September 15, 2010

**Re: Construction Storm Water Inspection at Havens Corner Office Park
Franklin County
Permit Number: 4GC02959*AG**

Figure 1: Structure fails to meet intent of appropriate sediment controls

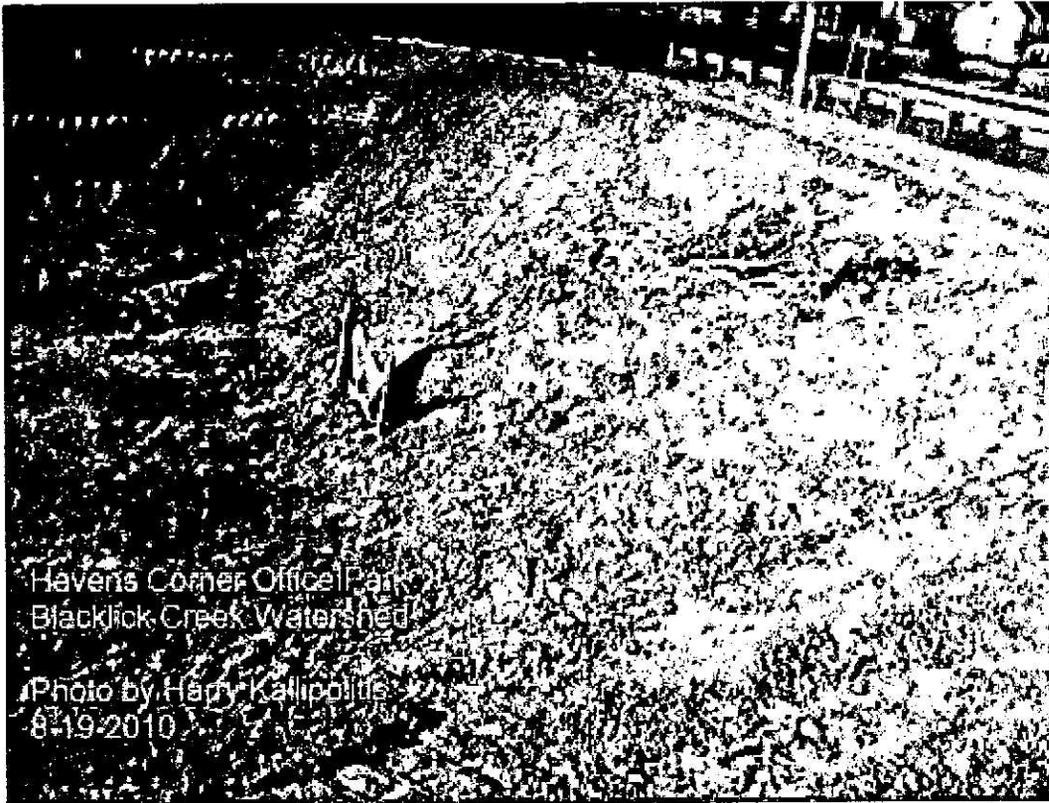
- The southern sediment basin has been installed.
- The silt fence directly in front of the outlet structure of this basin fails to meet the intent of appropriate sediment controls (see figure 1). A temporary riser/skimmer must be installed within 7 days from receipt of this letter.
- Entire site must be seeded prior to the onset of the winter months.
